SERVICE BULLETIN

M-1159

AUSTRALIAN STATIONARY NOISE LABEL

Figure 1 Noise Label Location/Sportster

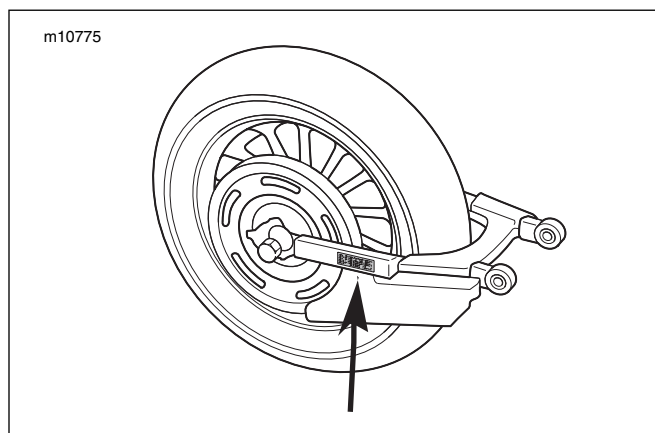
1. See [Figure 1](#) for Sportster models.
2. See [Figure 2](#) Buell Models.
3. See [Figure 3](#) for CVO model FLHTCSE.

1. Clean surface of old label with hot, soapy water. Thorough cleaning is necessary for new label to adhere to old label. Dry surface completely before installing new label.
2. Install new label over old label.

Figure 3 Noise Label Location/FLHTCSE

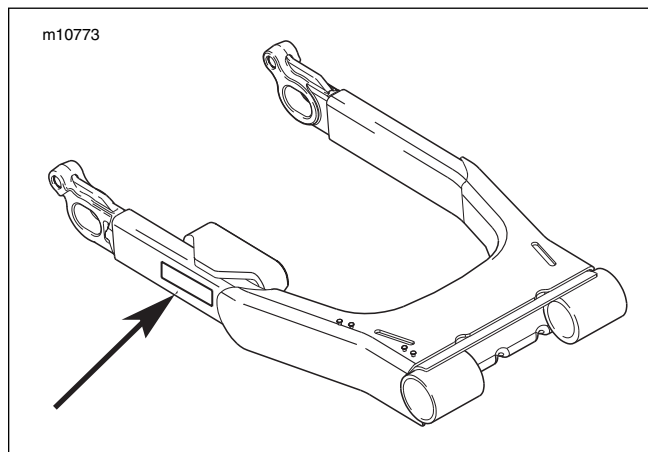
On FLHTCSEI models, it will be necessary to remove the right saddlebag assembly in order to install the noise label.

Figure 4. Noise Label for Australia (Typical) with Correct ADR Number

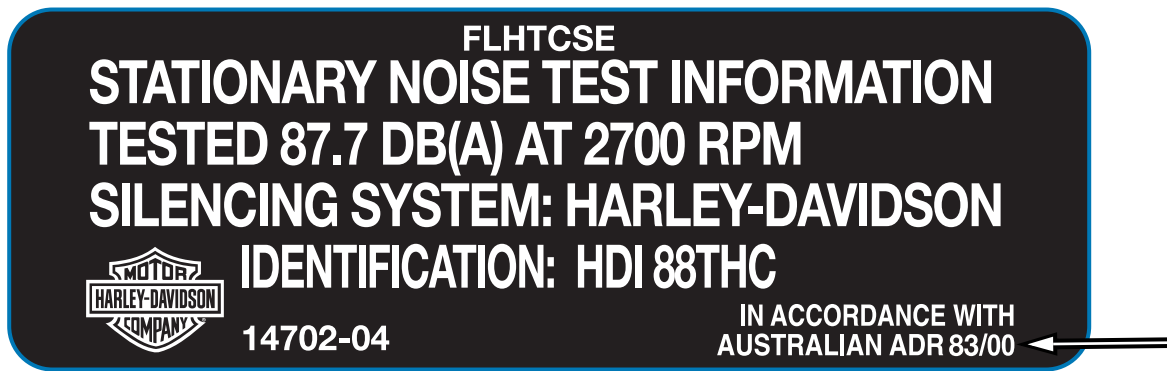
The purpose of this bulletin is to advise dealers that an incorrect noise label was installed on certain Australian motorcycles.

- The correct ADR number is 83/00. The old or incorrect ADR number is 39/00.
- DB level and RPM will be different for each model.

Install **new** label over old label when the bike is in for other Services. A new label for each vehicle shipped to your dealership is also attached.
